Digital ECU Tester Harness Inspection

Digital Diagnostic Terminal adapter harness
 84-822560A8

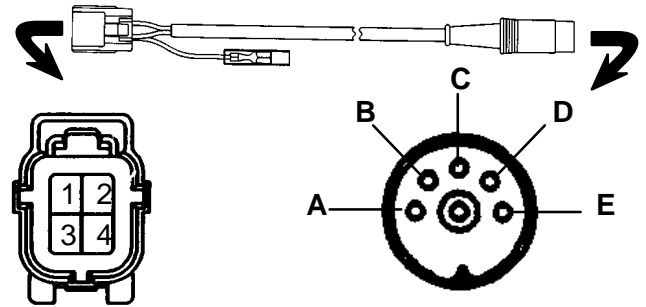
The harness may not be assembled correctly. Digital ECU boxes used on Hi-Performance 2.0 Litre, 2.5 EFI's and service replacement digital boxes for 2.4 EFI's will not be able to communicate with the DDT test unit.

If the harness has not been used or when used, there was a problem with getting any data, check the continuity between the following terminals on the harness.

TESTER END (four pin female)	ECU END (five pin male)
1	D
2	B
3	A (also red connector)
4	C
	E Vacant

If continuity is not correct, replace the harness. Return the old harness with a warranty claim and reorder the replacement harness using the same part number.
